Our Ref: JH/10622/jj

27 August, 2021

**RE: SECTION 4.55(2) MODIFICATIONS TO APPROVED
STATE SIGNIFICANT DEVELOPMENT APPLICATION FOR
ST ANTHONY OF PADUA CATHOLIC SCHOOL, AUSTRAL**

Figure 1

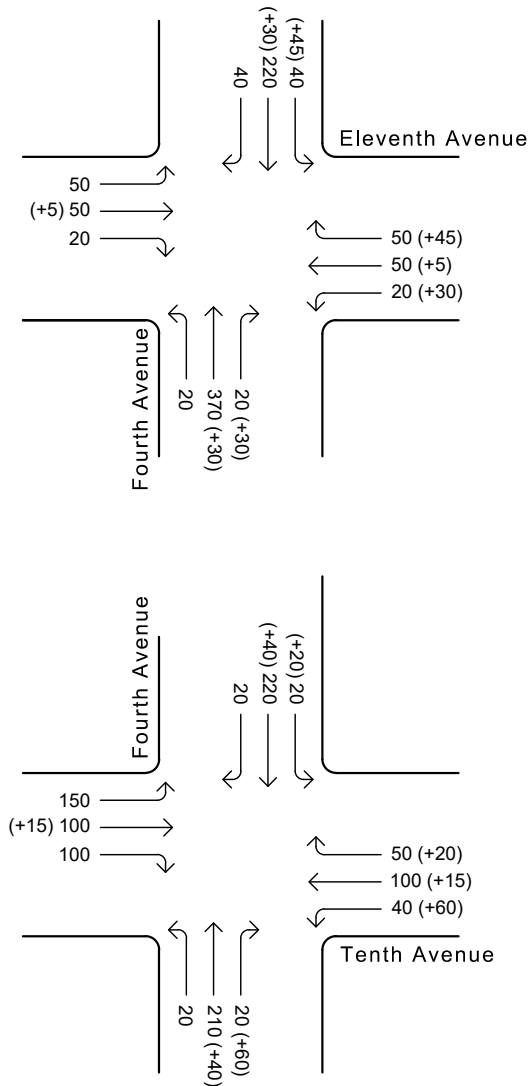
2. The DPIE letter of 4 August 2021 includes the following:
 7. *Provide a revised Traffic Report that:*
 - a) *Includes evidence to justify the proposed revised student capacity trigger for the completion of required roadworks, in particular the 1350 student trigger figure for the completion of roundabout works.*

10. Traffic flows through these two intersections during weekday morning and afternoon peak periods, plus traffic from the school with 1,350 students, are shown in the attached Figures 1 and 2. The base flows are the same as those in our original report, with the ultimate development of the Austral and Leppington North precincts.

11. The operations of the two intersections have been analysed with SIDRA for the interim intersection configurations and the traffic flows shown in the attached Figures 1 and 2.

14. The analysis found that with the interim arrangements, the intersections of Fourth Avenue with Tenth and Eleventh Avenues will operate with average delays for the highest delayed movements of less than 28 seconds per vehicle. This represents level of service B, a satisfactory level of service. Copies of the SIDRA output summaries are attached to this letter.

15. Therefore, both intersections would operate satisfactorily with a school population of 1,350 students and the interim arrangements, prior to roundabouts being provided.

Site: 101 [PM 2036 + 1350 students - Fourth Avenue - Tenth Avenue (2 Lane) (Stop)]

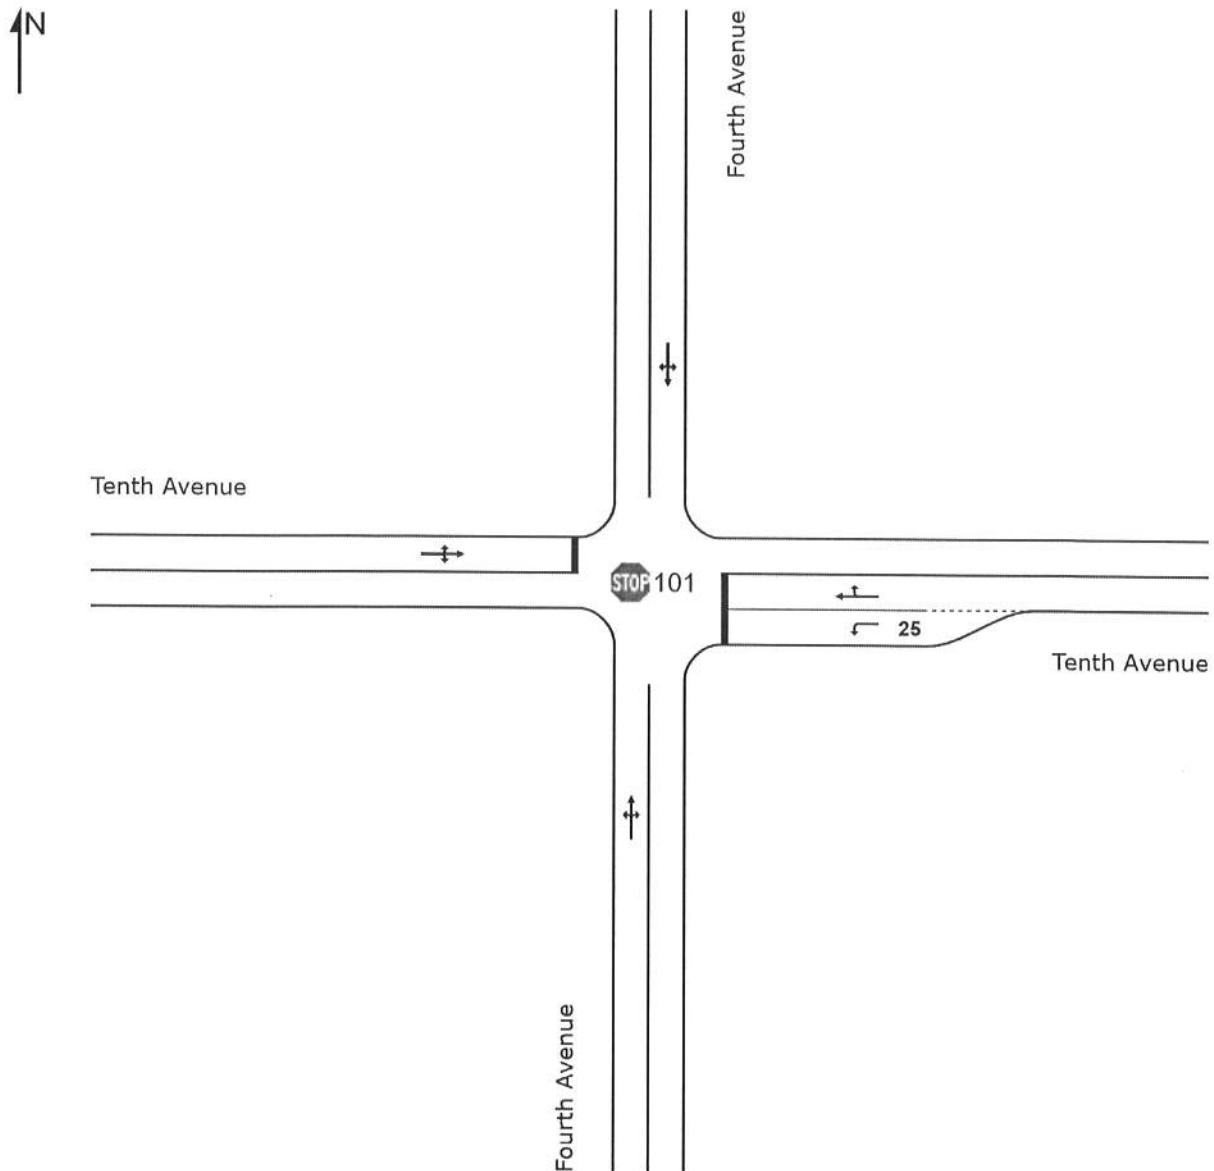
- at Fourth Avenue/Tenth Avenue – two approach lanes on Tenth Avenue (east), including a short left turn lane and a shared through/right lane. Stop signs provided on both Tenth Avenue approaches. This measure is not yet constructed.
